SUBJECT: ISSUANCE OF AMENDMENT NO. 99 TO FACILITY OPERATING LICENSE NPF-9 AND
AMENDMENT NO. 81 TO FACILITY OPERATING LICENSE NPF-17 - MCGUIRE
NUCLEAR STATION, UNITS 1 AND 2 (TACS 71141/71142)

Replace the following pages of the Appendix "A" Technical Specifications with the enclosed pages. The revised pages are identified by Amendment number and contain vertical lines indicating the areas of change.

SAFETY EVALUATION BY THE OFFICE OF NUCLEAR REACTOR REGULATION
RELATED TO AMENDMENT NO. 99 TO FACILITY OPERATING LICENSE NPF-9
AND AMENDMENT NO. 81 TO FACILITY OPERATING LICENSE NPF-17

Figure 3/4 7-1
Nuclear Service Water System

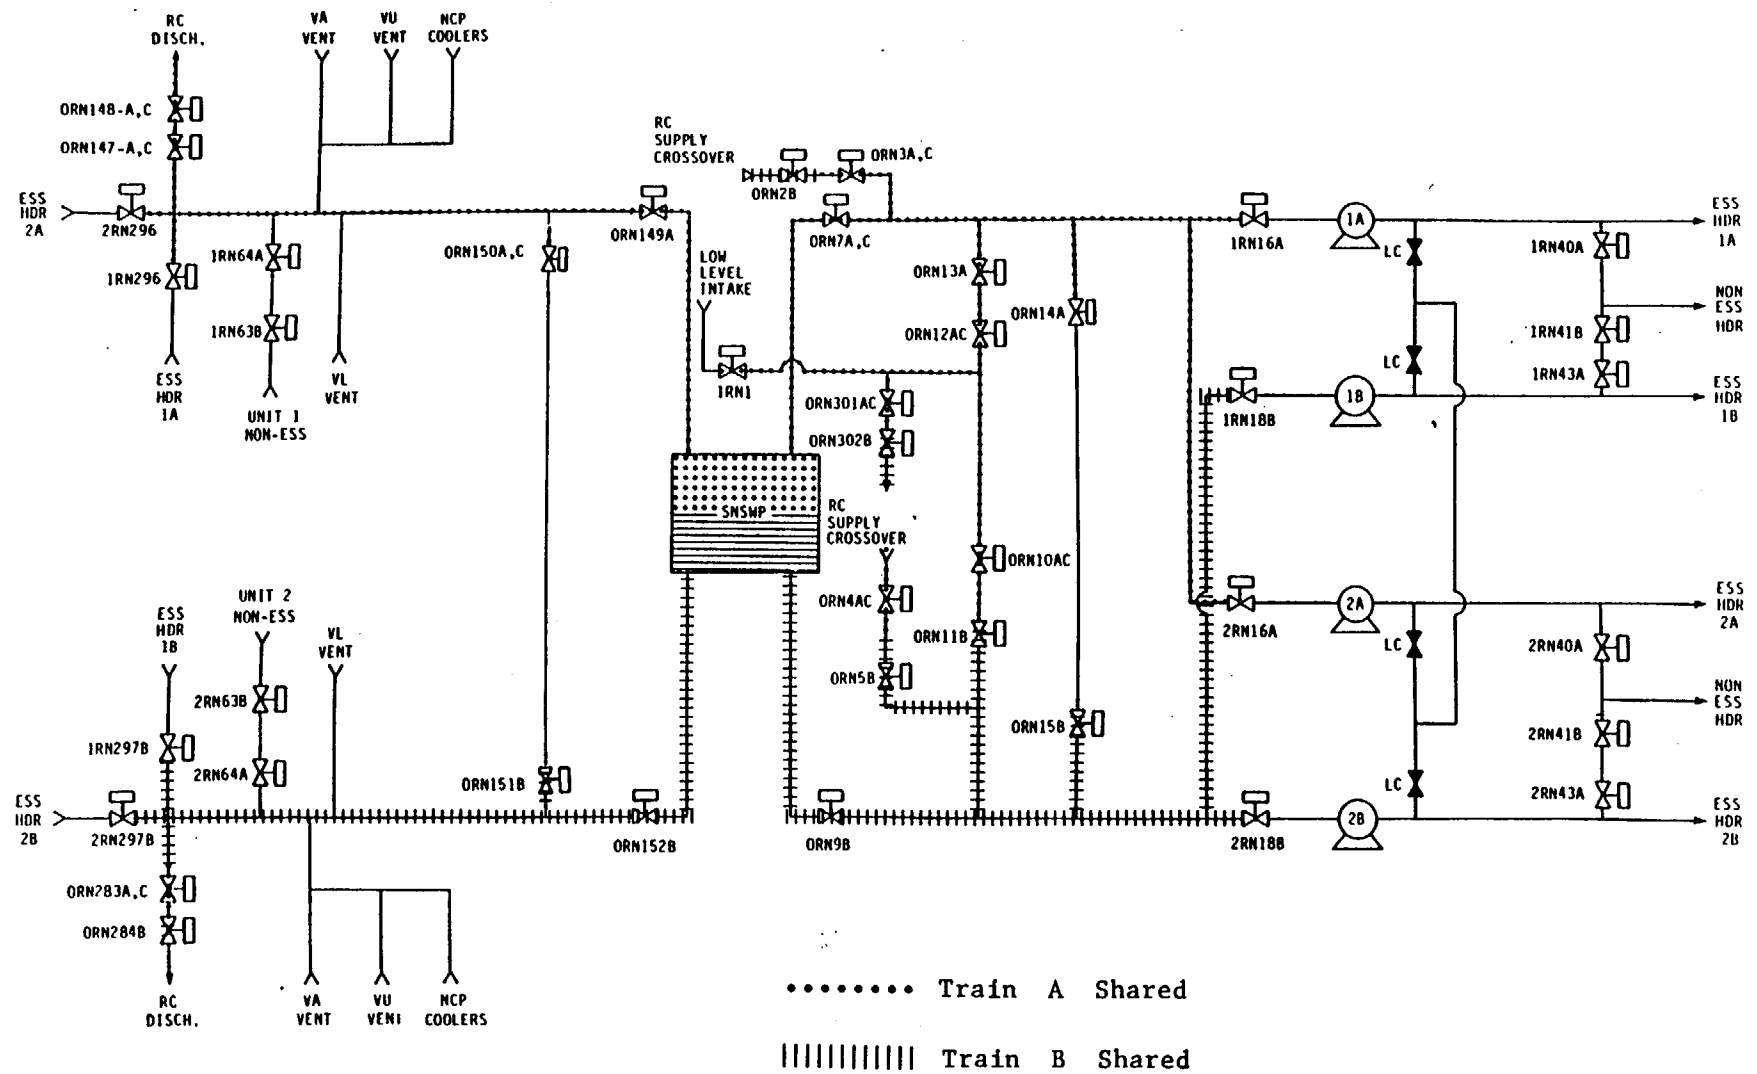
The amendments change the Technical Specifications by replacing Figure 3/4 7-1 "Nuclear Service Water System" with a more legible one and correcting a typographical error. The amendments are effective as of their date of issuance.

Also, TS Figure 3/4 7-1, "Nuclear Service Water System (NSWS) will be replaced by a more legible figure, with full (rather than abbreviated) valve designations.

The intent of TS Figure 3/4 7-1 is to designate which lines and valves of the NSWS are shared between the two McGuire units. If a shared component of the NSWS becomes inoperable, both units are affected, and both units must comply with the ACTION requirements of TS 3.7.4b, "Nuclear Service Water System." The proposed changes to Figure 3/4 7-1 make it clearer to plant operating personnel which NSWS components are shared between the two units. The revised line and valve designations do not make any change in existing system design, equipment, power source or plant operating practice.

Accordingly, the proposed changes to correct a typographical error and substitute an improved figure are of an administrative nature and have no adverse impact on safety. They are, therefore, acceptable.
